SECTION 00 9113.3 - ADDENDUM 3

- A. Project Name: **Wee Links Pro Shop Shelter Addition.**
- B. Owner: **Minot Park District**
- C. Architect: **Ackerman-Estvold, Engineering & Management Consulting, Inc.**
- D. Architect Project Number: **R25104.01.**
- E. Date of Addendum: **3/9/26.**

- A. This Addendum includes the following attached Sheets:
 - 1. Architectural Sheet A100 – Floor Plan, Roof Plan, RCP, & Details (reissued).

2 REFLECTED CEILING PLAN
A100 SCALE: 1/8" = 1'-0"

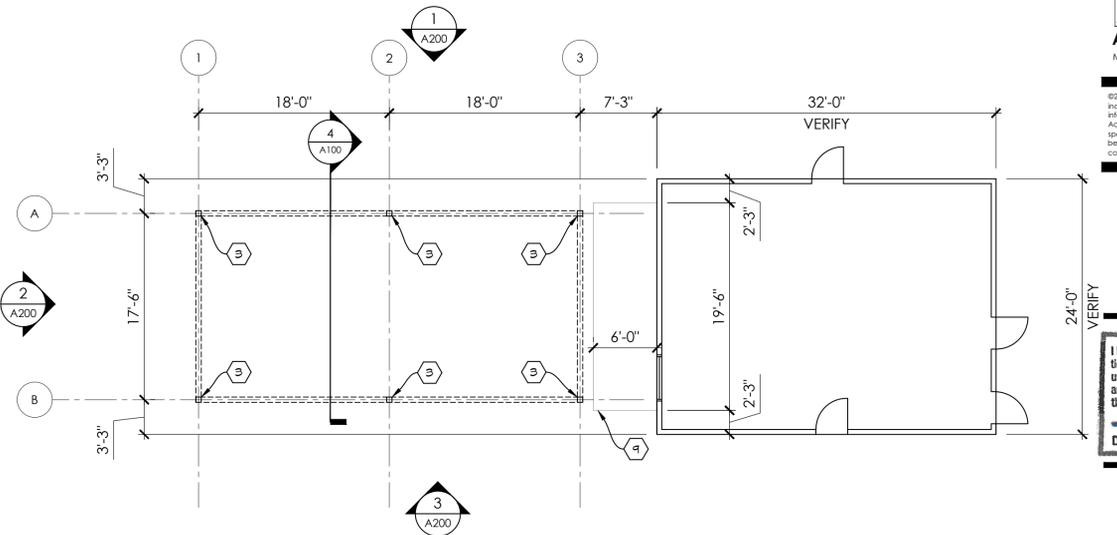
- A. Replaced composite boards on the soffits and ceiling with a preformed steel cladding system.

- 1 LVL BEAM - SEE STRUCTURAL
- 2 PREFORMED METAL CEILING & SOFFIT - SEE SPEC.
- 3 STEEL COLUMNS - SEE STRUCTURAL - PAINTED
- 4 RE-SHINGLE THIS SURFACE OF EXIST. ROOF FOR CONNECTING LINK TIE-IN
- 5 ARCHITECTURAL ASPHALT SHINGLE SYSTEM - MATCH EXISTING COLOR
- 6 CUPOLA - SEE DETAIL 10/A100
- 7 EAVE - SEE DETAIL 5/A100
- 8 NEW CONCRETE SLAB - SEE CIVIL
- 9 NEW CONCRETE PLATFORM - SEE CIVIL
- 10 PREFORMED METAL SOFFIT - VENTED FIRST 12" OF SOFFIT.
- 11 RIDGE VENT
